Access Compliance Report Public Rights-of-Way (Curb Ramps)

Main Street: HEWES_AVE Cross Street: HEATHER_GLEN Location: E

ADA ID: RPRK220125130755 Ramp Type: Type 4 - Parallel Initial Pass/Fail: Fail Overall Compliance: No Severity Score: 16

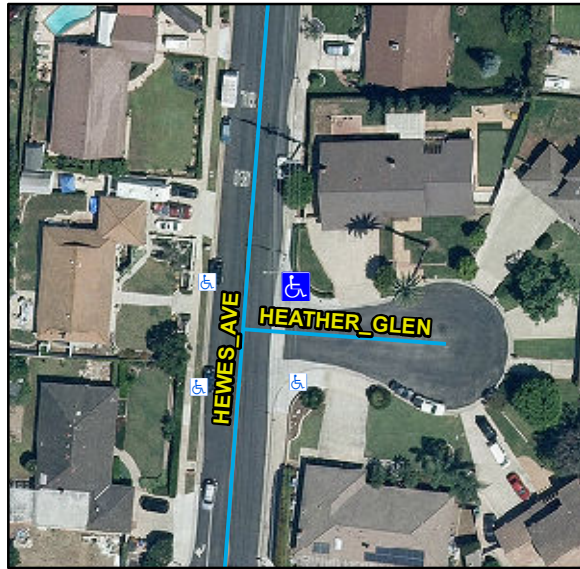
R304.3.2, STD 1115

Compliance	Description	Data	Compliance	Description	Data
N/A	Ramp Length LT (in)	110	N/A	Ramp Length RT (in)	68
Yes	Ramp Width LT (in)	48	Yes	Ramp Width RT (in)	48
Yes	Ramp Run Slope LT (%)	7.4	No	Ramp Run Slope RT (%)	8.6
Yes	Ramp Cross Slope LT (%)	1.3	Yes	Ramp Cross Slope RT (%)	2
N/A	Landing Present	N/A	N/A	DWS Provided	N/A
N/A	Landing Length (in)	N/A	N/A	DWS Contrast	N/A
N/A	Landing Width (in)	N/A	N/A	DWS Length (in)	N/A
N/A	Landing Run Slope (%)	N/A	N/A	DWS Full Width	N/A
N/A	Landing Cross Slope (%)	N/A		DWS Offset Type	N/A
N/A	Landing Movement Obstructed?	N/A	N/A	DWS Offset Left (in)	N/A
	Landing Movement Type	N/A	N/A	DWS Offset Right (in)	N/A
N/A	Landing Shared	N/A			
N/A	Clear Space	Yes			
N/A	Clear Space To Crosswalk (in)	N/A			
N/A	Marked Crosswalk 1	No	N/A	Marked Crosswalk 2	No
	Crossing 1 Direction	NW		Crossing 2 Direction	SW
	Marked Crosswalk 1 Width (in)	N/A		Marked Crosswalk 2 Width (in)	N/A

Remove & Replace Curb Ramp With Two New Directional Ramps or Equivalent.
